**RE: FORT STREET PUBLIC SCHOOL - OBSERVATORY HILL, UPPER FORT ST, MILLERS POINT
BCA AND DDA COMPLIANCE STATEMENT FOR SSDA SUBMISSION**

This statement has been prepared to verify that Blackett Maguire + Goldsmith Pty Ltd have undertaken a review of the architectural documentation that will accompany the State Significant Development Application (SSDA) for the proposed Millers Point development against the Building Code of Australia 2019 (BCA) and Access to Premises Standard 2010.

Figure 2: Building Identification

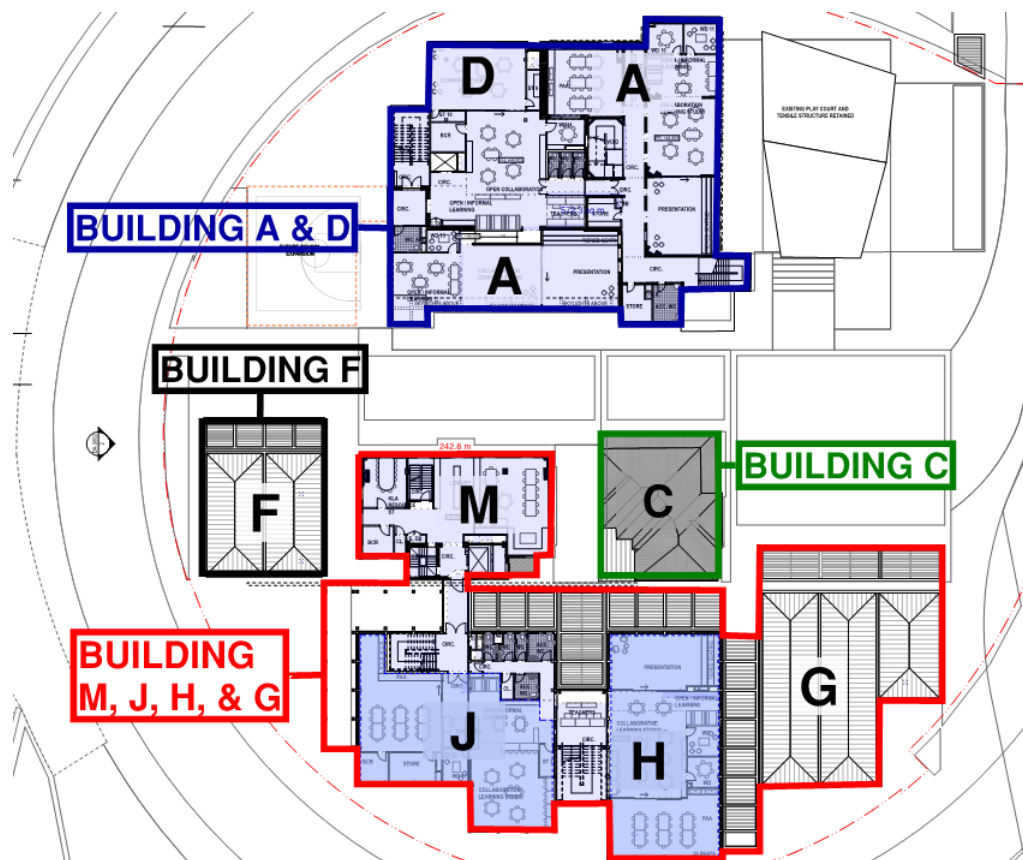
1. **C1.1 / Spec. C1.1** Loadbearing columns and walls serving Building A & D and Building M, J, H, & G are to be documented to achieve a 120 Minute FRL. Where any steel columns are proposed, the method of fire rating the columns is to be documented as part of the detailed design.
The roof of Building M, J, H, & G is to be fire rated to achieve a minimum 120-minute FRL.

4. **C2.2** Total floor area and volumes for Building A & D and Building M, J, H, & G are required to demonstrated that the respective buildings do not exceed the maximum permitted 8,000m² / 48,000m³

7. **D1.8** It is understood that the Western Circulation Stair located in Building A & D is proposed to be designed as a D1.8 External Stair in lieu of a Fire Isolated Stair. Accordingly, the detailed design drawings are to be demonstrate compliance with BCA Clause D1.8

8. **D2.8** The storage below the Eastern Circulation Stair in Building A & D is to fire separated from the remainder of the stair and building by construction which achieves a minimum an FRL of 60/60/60, with a self-closing -/60/30 door. This is to be documented on the detailed design drawings.
Noting that the Central Circulation Stair in Building A & D is proposed to be addressed as a Fire Engineered Performance Solution, the toilet located below the stair on the ground floor level is either to be removed/relocated or assessed as part of this Performance Solution.

- Access to Building M, J, H, & G from the Existing Footbridge is required
 - The lift access proposed under the COLA at the rear of the MET Building is to demonstrate compliance with both BCA Table E3.6a and EFSG requirements.
